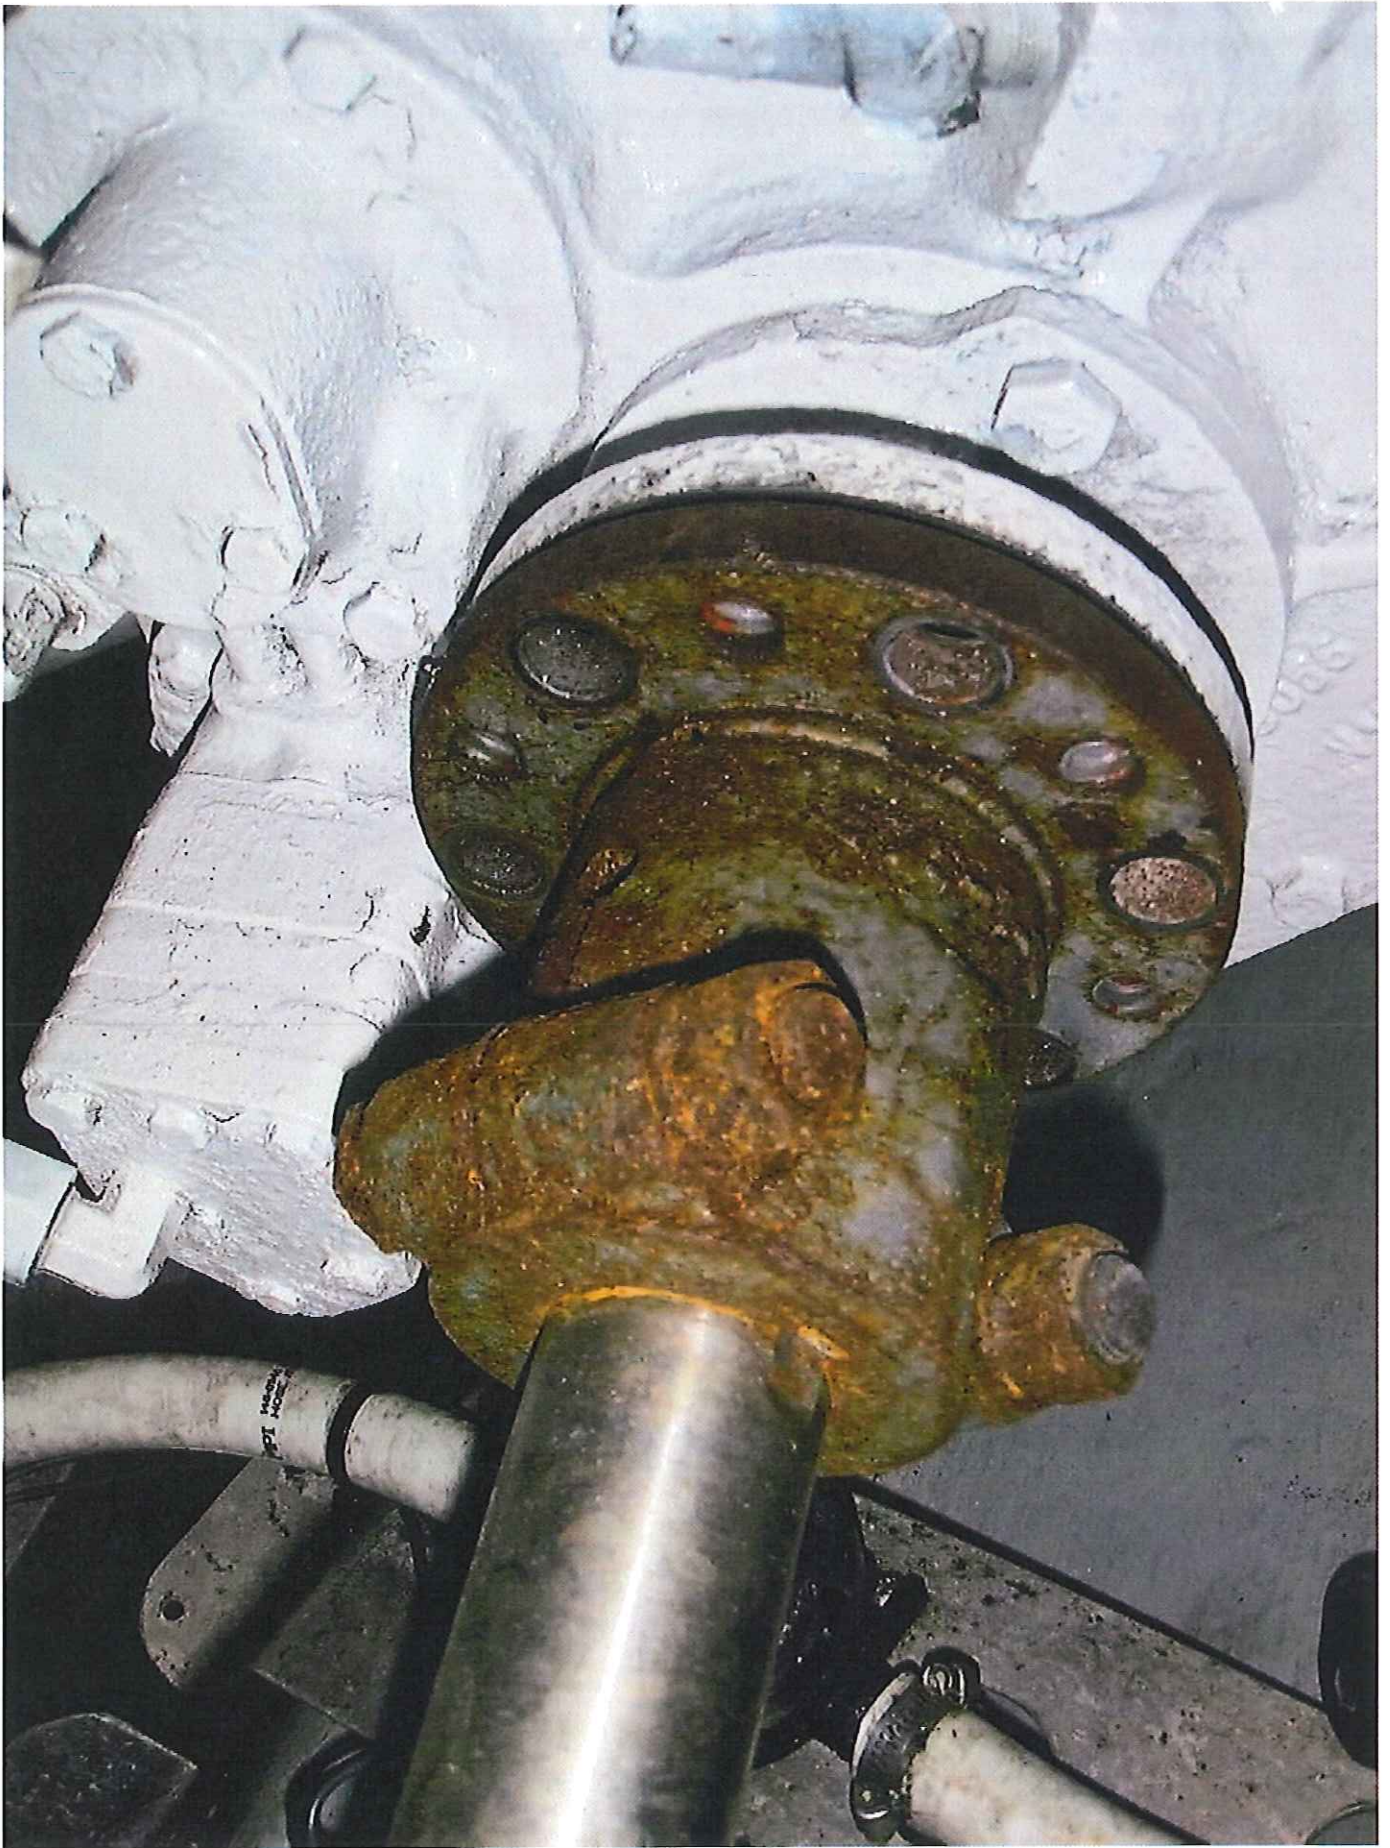
Loop in the crossover fuel line that should be eliminated to prevent a "water collection" area

Shut off valve should be added

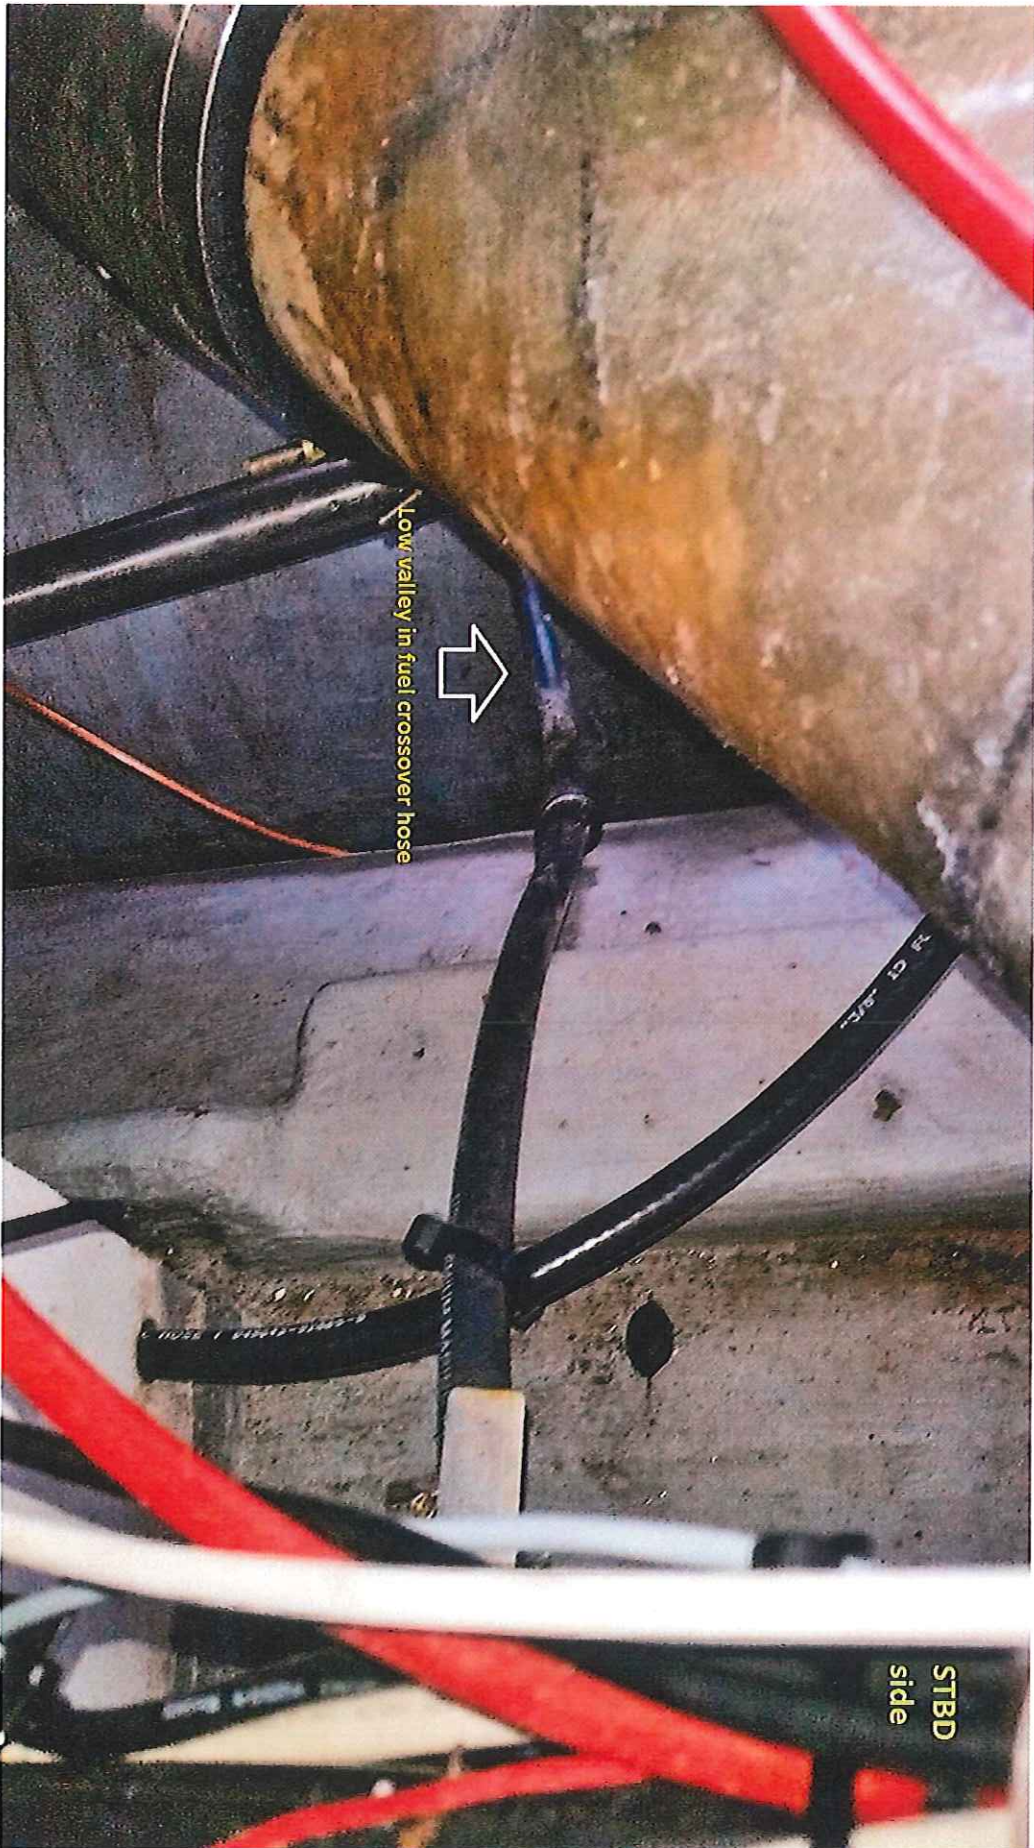
NO shut-off valve on the PORT fuel tank  
(see ADAC H33.14.2)

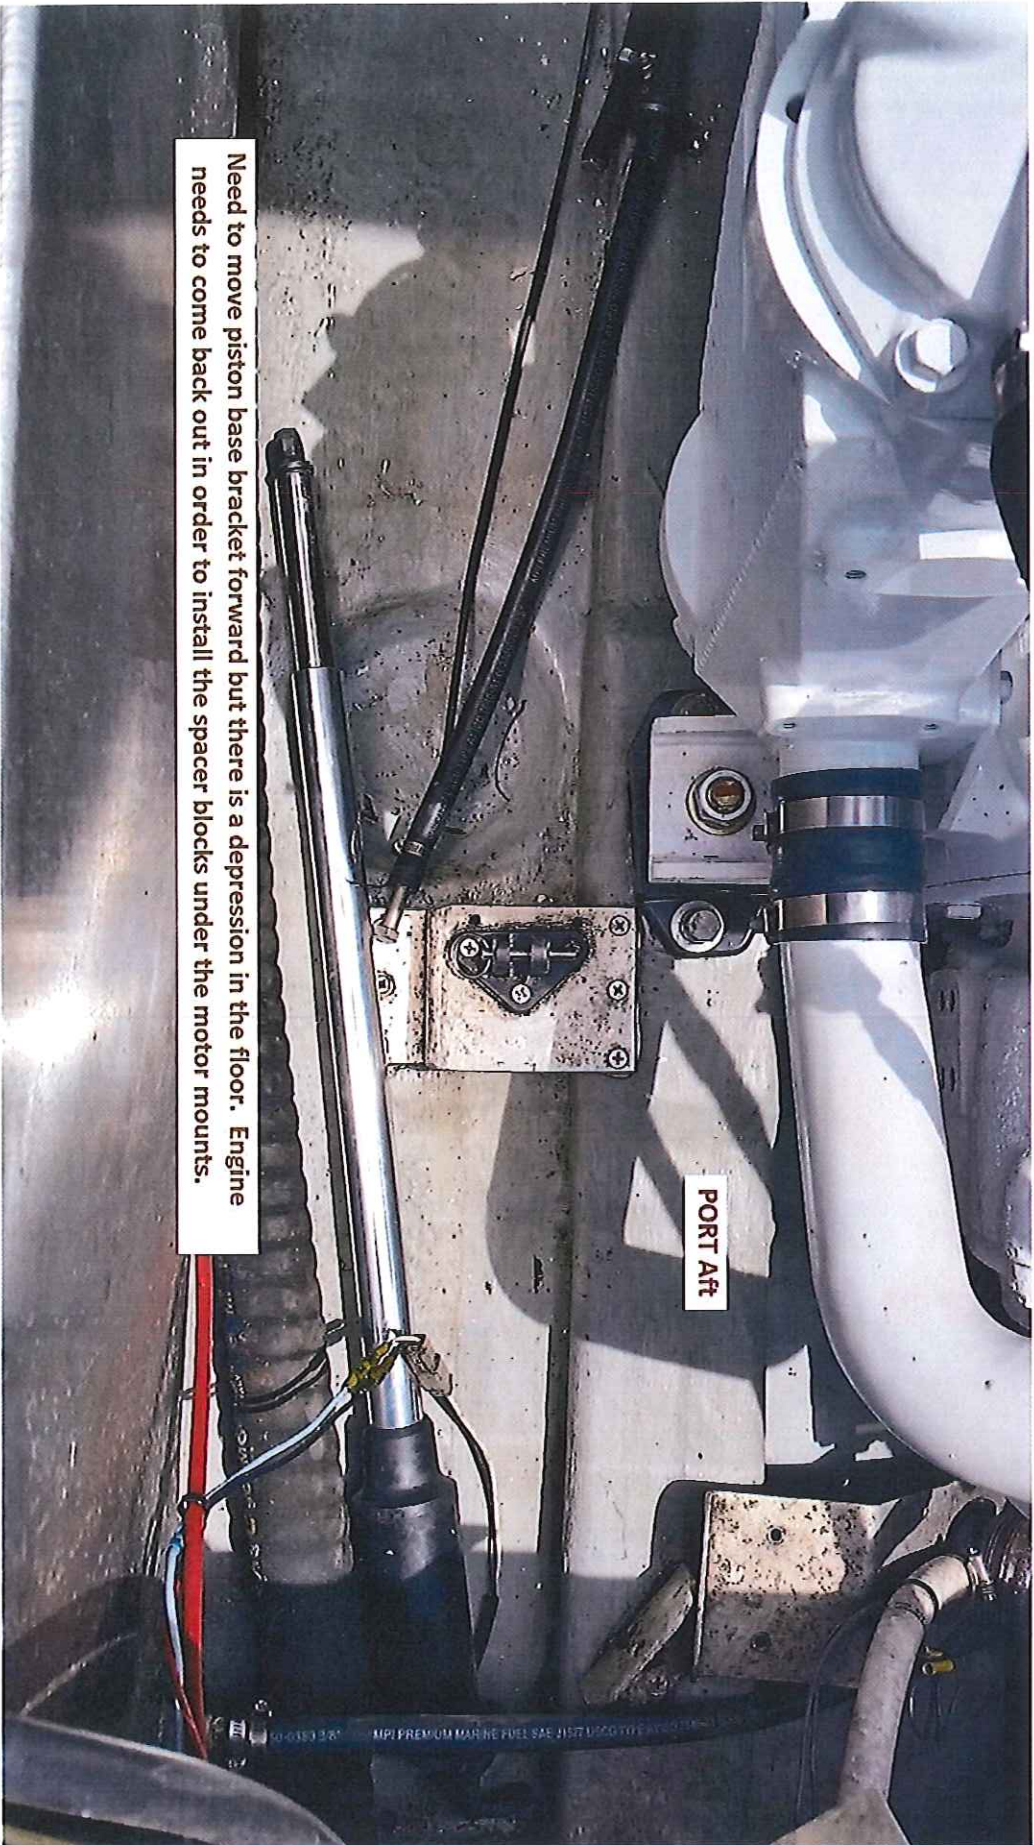
Need to move piston base bracket forward but there is a depression in the floor. Engine needs to come back out in order to install the spacer blocks under the motor mounts.
